# Office Action Summary

10/549,394

TSUJI ET AL.

## **DETAILED ACTION**

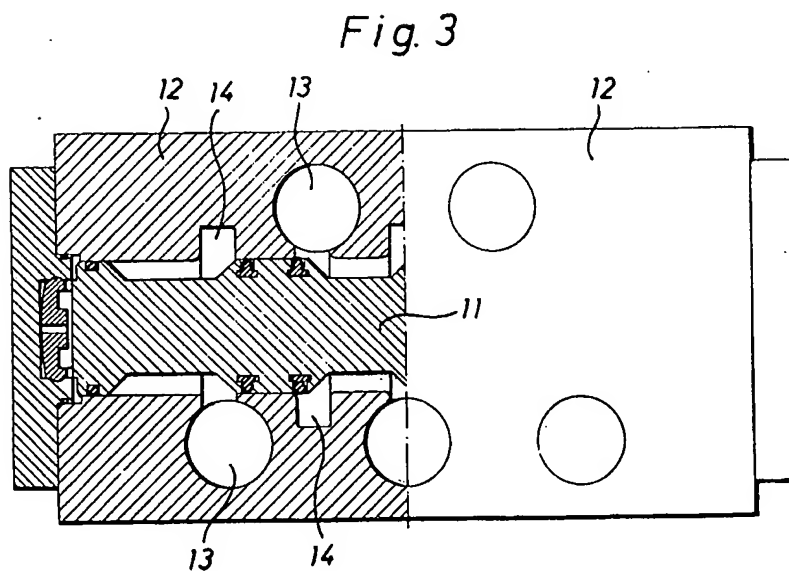
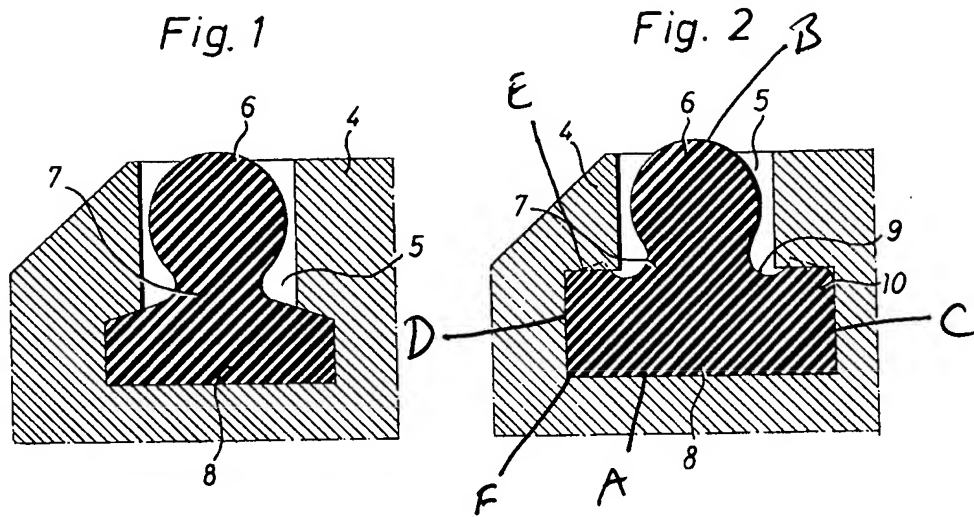
Regarding claim 1, the Engstrom reference discloses a sealing material (Col. 2, Line 8) for an ant groove (5), which is fitted to the ant groove made in a surface of either one of members in a joint place (11, 12) between these members and contacts with a surface of the other member (Fig. 3), thereby sealing both the members, with the sealing material comprising:

a sectional shape (Fig. 2) having a straight bottom edge (A) which is disposed on a bottom face of said ant groove (Fig. 2); an arched convex edge (B) which contacts

with the surface of said other member facing said ant groove (Fig. 3); a first projecting edge (C) which connects with one end of said bottom edge and projects outside (Fig. 2); a concave inlet portion (9) which is located between said first projecting edge and said arched convex edge (Fig. 2); a second projecting edge (D) which connects with the other end of said straight bottom edge and is composed of straight lines that project outside (Fig. 2); a straight sloping edge (E) of which one end connects with the opposite end of said arched convex edge as to said first projecting edge and of which the other end connects with said second projecting edge (Fig. 2); and at least one corner portion (F) which is constituted in the range of from said straight bottom edge via said second projecting edge to said sloping edge (Fig. 2). Note that the English equivalents to the patents described in the specification recite that the groove is an annular groove and has been treated as such for the examination of this application. Also note that the straight slope is connected to the arched convex edge through a concave portion (Fig. 2).

FIG. 3

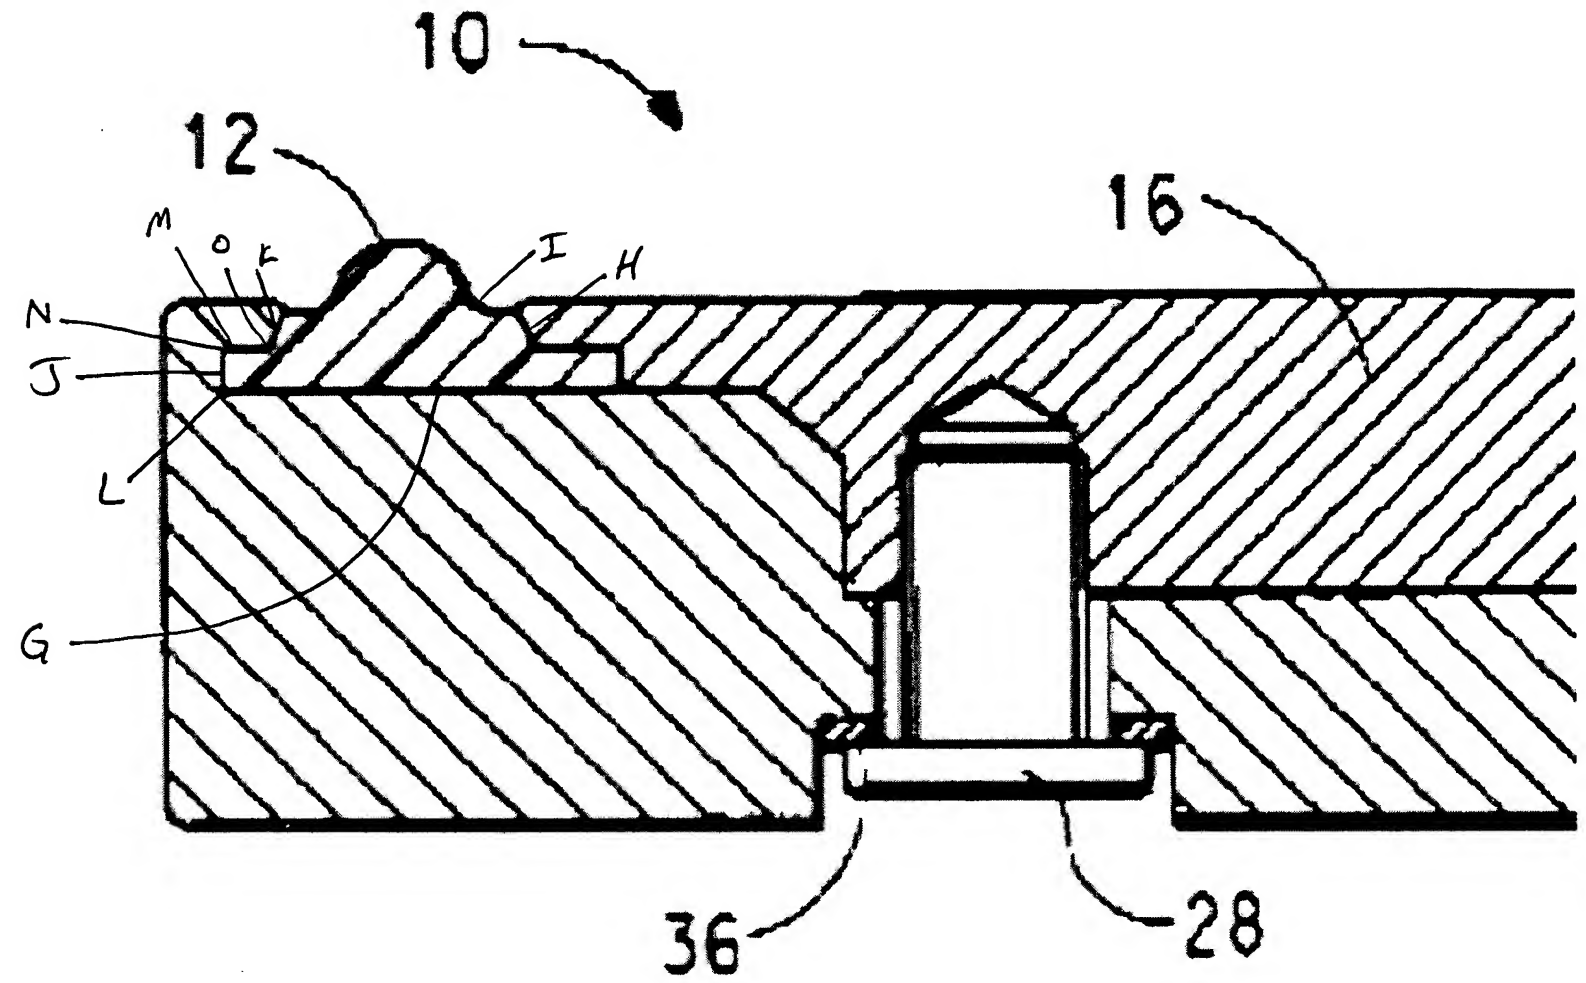
Regarding claim 1, the Kane et al. reference discloses a sealing material (Col. 1, Lines 35-36) for an ant groove (Col. 2, Lines 18-22), which is fitted to the ant groove made in a surface of either one of members in a joint place (e.g. 14 and 16 comprising one member and the second member being discloses in Col. 3, Lines 1-4) between

a sectional shape (Fig. 3) having a straight bottom edge (G) which is disposed on a bottom face of said ant groove (Fig. 3); an arched convex edge (12) which contacts with the surface of said other member facing said ant groove (Fig. 3); a first projecting edge (H) which connects with one end of said bottom edge and projects outside (Fig. 3); a concave inlet portion (I) which is located between said first projecting edge and said arched convex edge (Fig. 3); a second projecting edge (e.g. J and M) which connects with the other end of said straight bottom edge and is composed of straight lines that project outside (Fig. 3); a straight sloping edge (K) of which one end connects with the opposite end of said arched convex edge as to said first projecting edge and of which the other end connects with said second projecting edge (Fig. 3); and at least one corner portion (e.g. L) which is constituted in the range of from said straight bottom edge via said second projecting edge to said sloping edge (Fig. 3). Note that the English equivalents to the patents described in the specification recite that the groove is an annular groove and has been treated as such for the examination of this application. Also note that the straight slope is connected to the arched convex edge through a concave portion and horizontal edge (Fig. 3).

Regarding claim 3, the Kane et al. reference discloses said second projecting edge being formed by connecting a pair of straight edges (J and M) together in a triangular shape; and

said corner portion being constituted in the following three places: a place between said straight bottom edge and said second projecting edge (L); a crooked place of said second projecting edge (N); and a place between said second projecting edge and said sloping edge (O).
